RE: **Lot 9 Block 4, Volcano Cliffs Unit 19, SAD 228**
6524 Azor Lane NW
Grading and Drainage Plan
Engineers Stamp Date 10/18/17 (D10D003T9)

ENGINEER'S SEAL	6524 AZOR LANE NW CURTIS RESIDENCE		DRAWN BY: MCM	DATE: 10-15-17
	GRADING AND DRAINAGE PLAN		2017-10-15-17	SHEET #
10/18/17		Pico Grande Engineering		
10/17/17		1606 CENTRAL AVENUE SE		
DAVID SOULE		ALBUQUERQUE, NM 87106		
P.E. #14522		JOB # 21811

RE: **Lot 9 Block 4 SAD 228**
Volcano Cliffs Subdivision
6524 Azor Lane NW
Grading and Drainage Plan
Engineers Stamp Date 10/17/17 (D10D003T9)

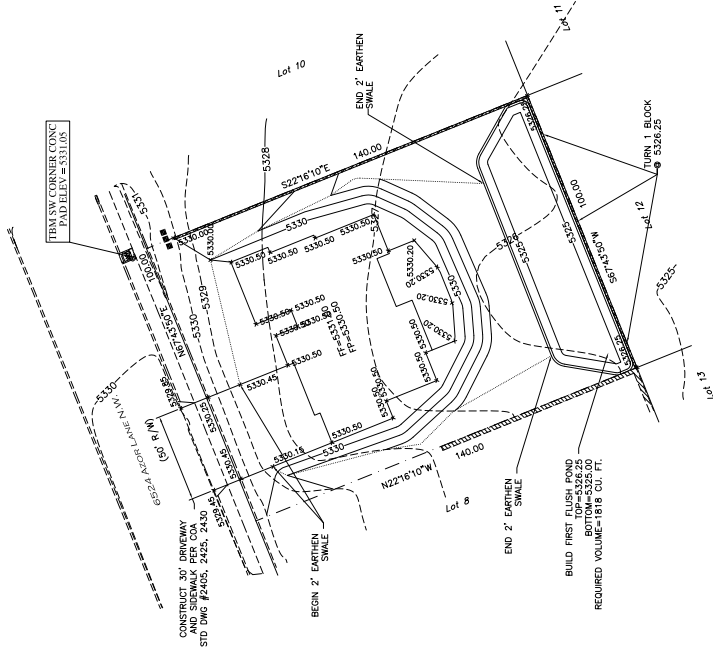
- Provide a statement on the plan stating that this grading plan must be used and provided for the application of any garden/retaining walls.

1. ALL SPOT ELEVATIONS REPRESENT FLOWLINE ELEVATION UNLESS OTHERWISE NOTED.
2. SLOPES SHALL BE 3:1 MAX. AND GRAVEL OR NATIVE SEEDING SHALL BE USED.
3. EROSION CONTROL REQUIRED PRIOR TO BUILDING PERMIT.
4. ANY ON-SITE PERIMETER WALLS MUST CONFORM TO THIS PLAN. A COPY OF THIS PLAN MUST BE SUBMITTED WITH WALL PERMIT APPLICATION.

ADDED
